DOCKETED	
Docket Number:	22-SPPE-02
Project Title:	San Jose Data Center 04
TN #:	266906
Document Title:	Valley Water ROC
Description:	Record of Conversation between Carol Watson_CEC and Lisa Brancatelli_Valley Water-SJDC 04
Filer:	susan fleming
Organization:	California Energy Commission
Submitter Role:	Commission Staff
Submission Date:	10/29/2025 1:04:40 PM
Docketed Date:	10/29/2025

San José Data Center 04

22-SPPE-02

☒ Telephone April 12, 2023	☒ Email April 14 and 19, 2023	☐ Meeting Location:	
NAME: Carol Watson, Staff Biologist California Energy Commission (CEC)		DATE: April 12, 2023	TIME: pm
WITH: Lisa Brancatelli, Matthew Sasaki, and Andrew Quan, Valley Water (Santa Clara Valley Water District)			
SUBJECT: Valley Water Notice of Preparation Comment Letter and other Biological Issues

Figures Received via email on April 14, 2024 @ 11:15am from Lisa Brancatelli

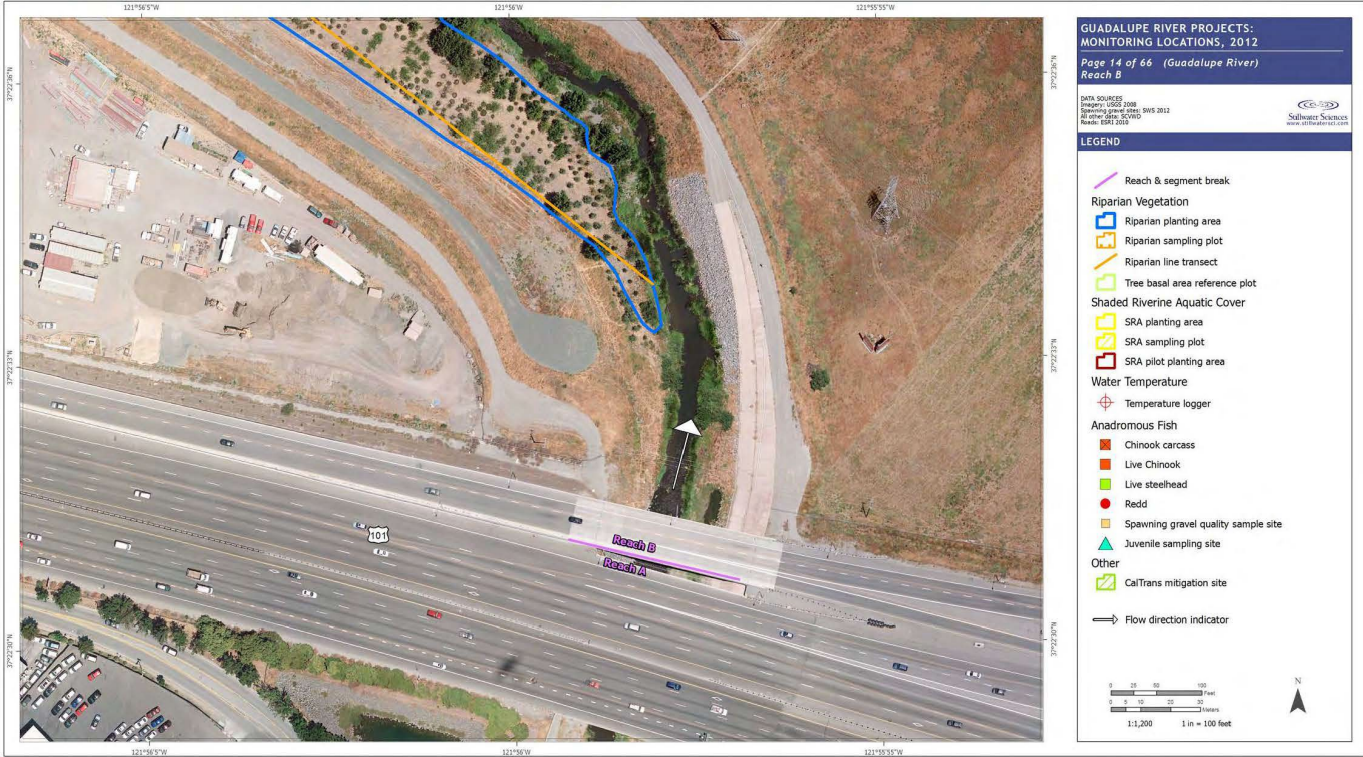
- 2. Where exactly are the mitigation areas and how big are they? (I'm not sure how accurately our mitigation areas are shown in GIS). Approximately 900-foot-long/2-acre planting area on the southwest bank of the river, just upstream of Hwy 101. See attached maps. (Our mitigation areas in GIS should be reliably accurate.)*
